CLIENT	Fortis Development Group
JOB	1728 Fortis South Steyne 34-35 South Steyne Manly NSW

PROJECT NO.	ISSUE	REV.
1728	S4.55	DA-L
DRAWING NO.		
A-DA-110-000

CHANGES RELEVANT TO THIS MODIFICATION APPLICATION

1:100

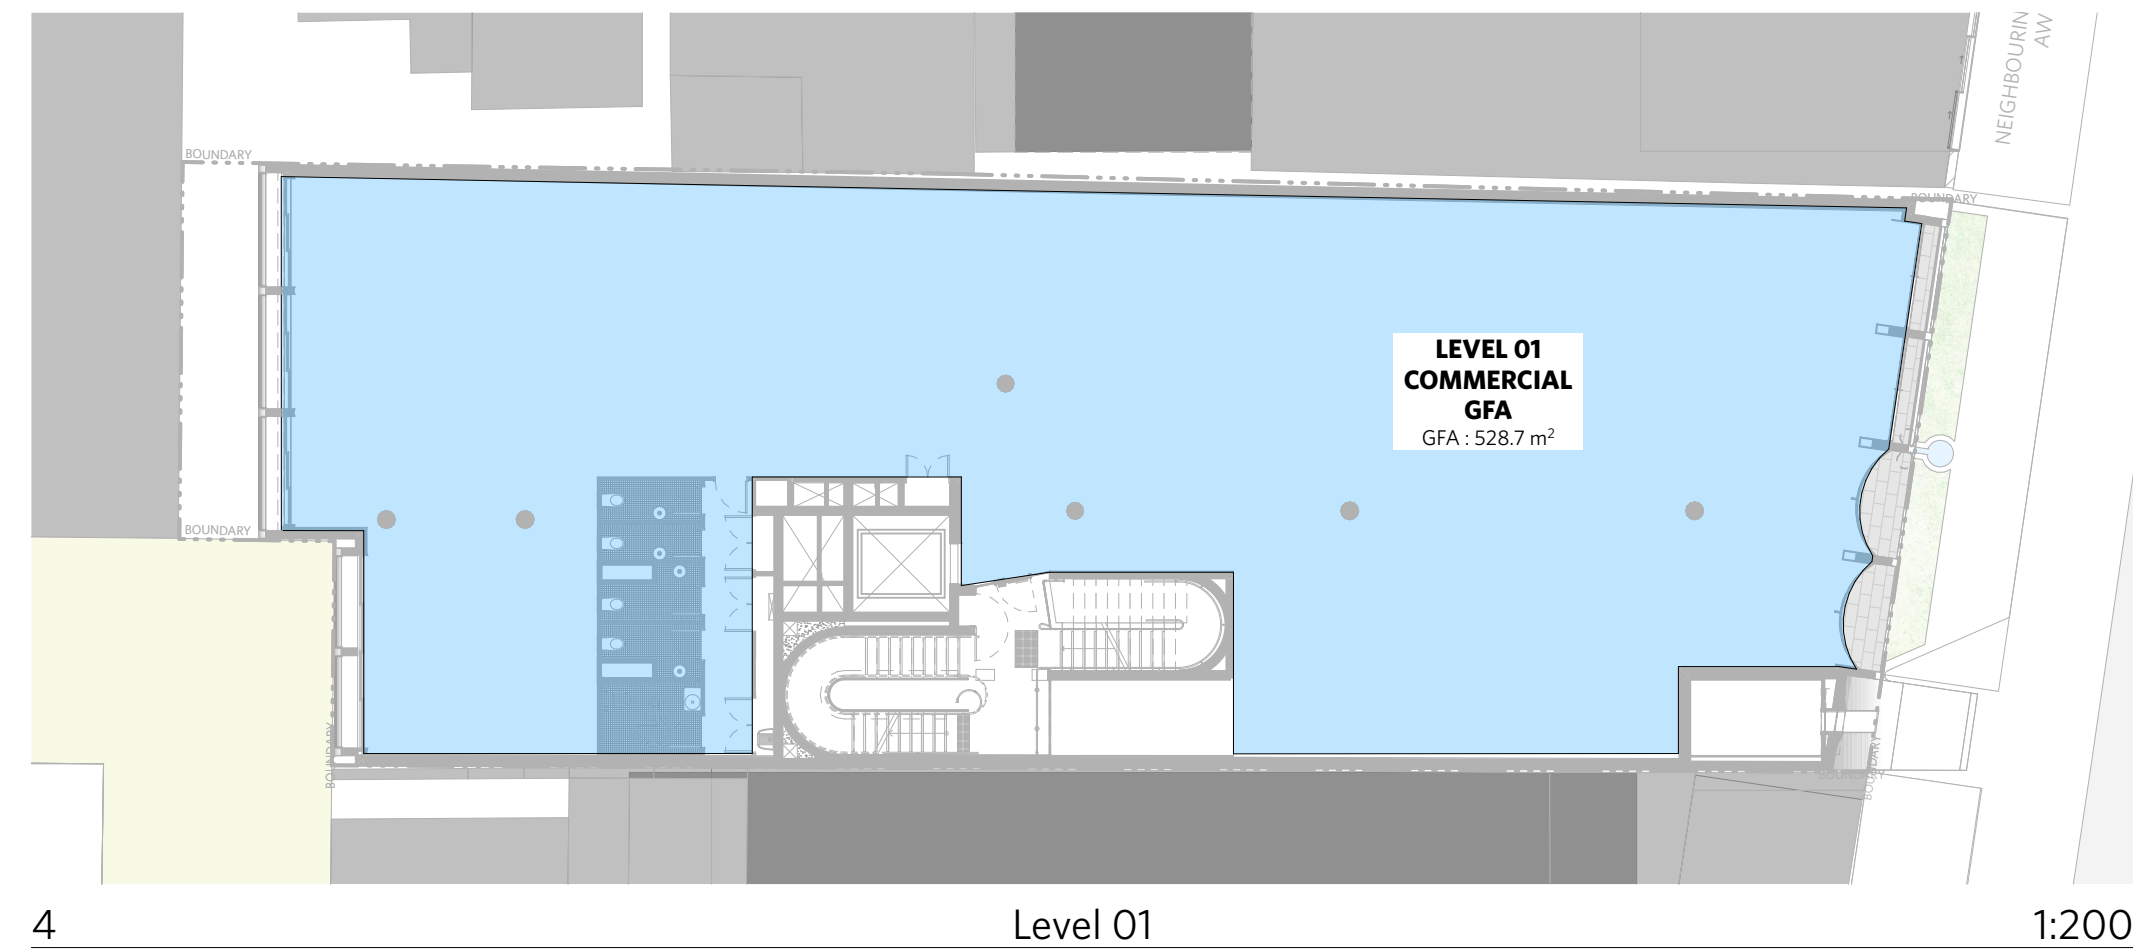
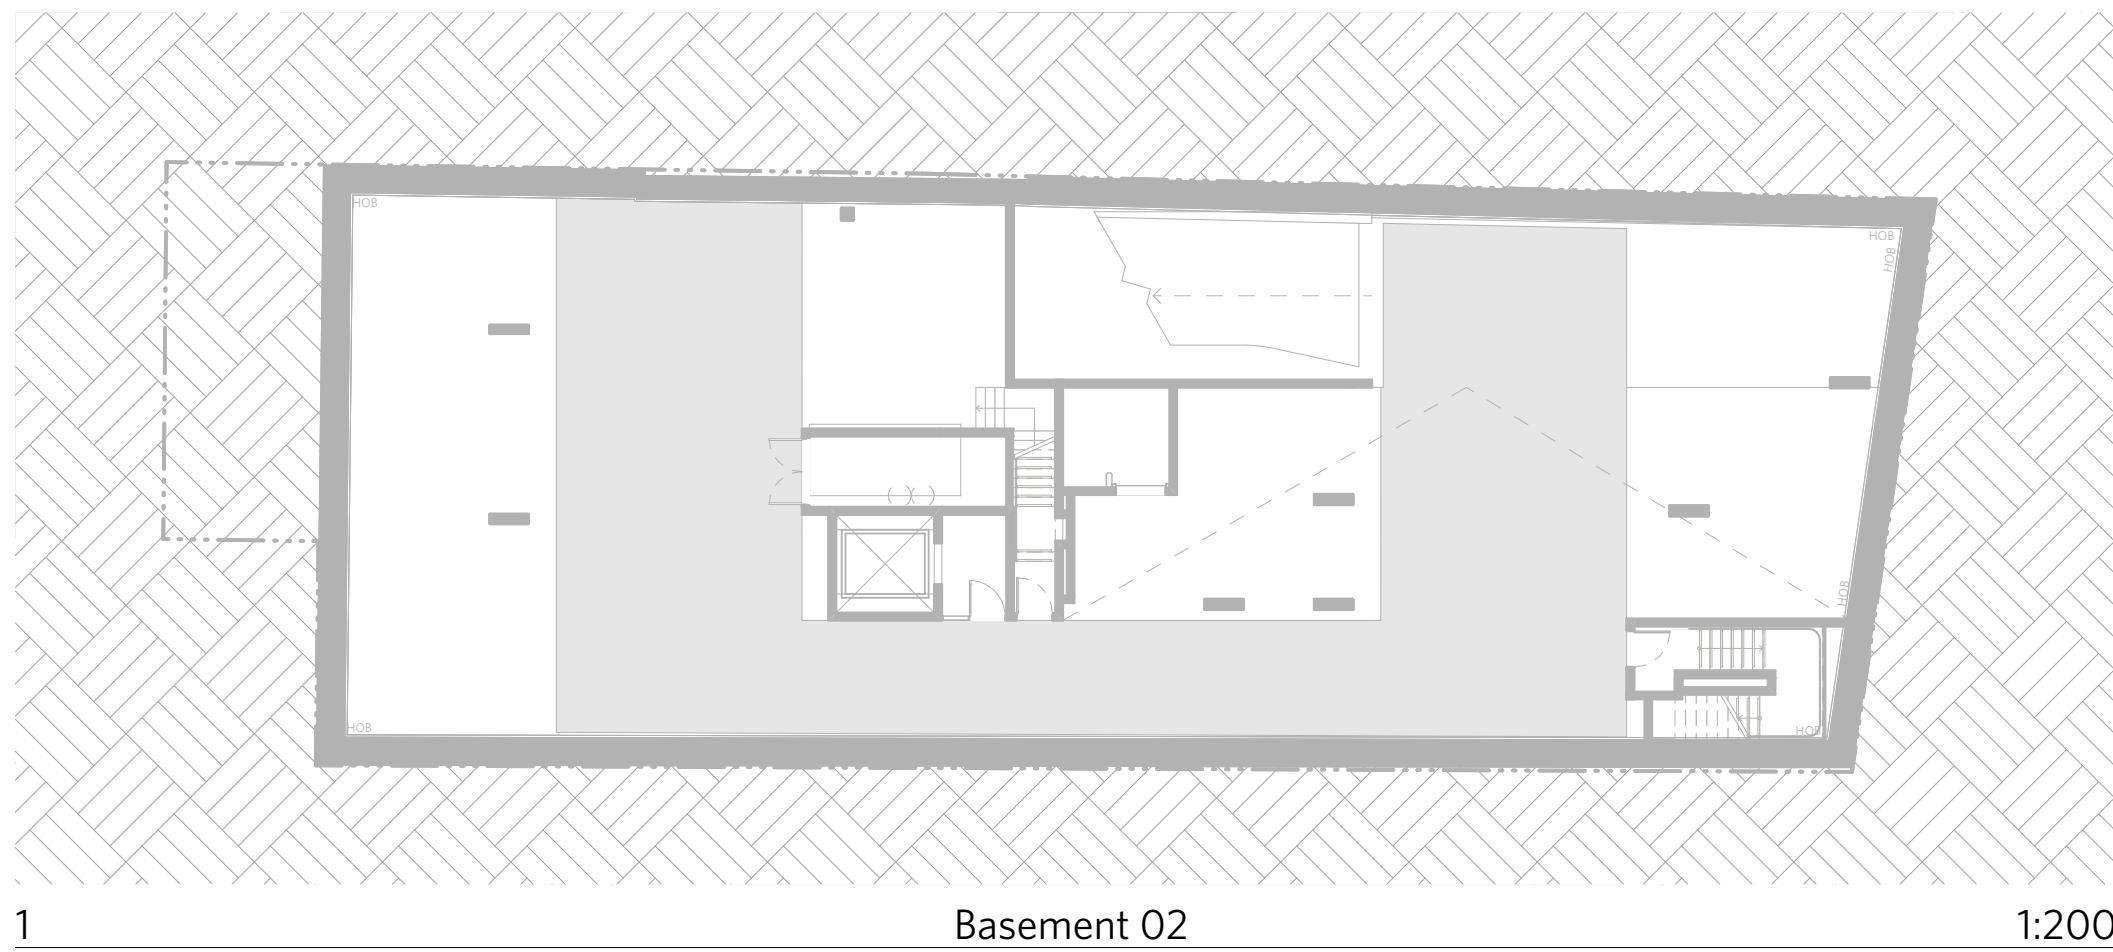
CHANGE SUMMARY		
REV	CHANGE	DESCRIPTION
DA-L	36	Change of Layout to Level 03 Floor
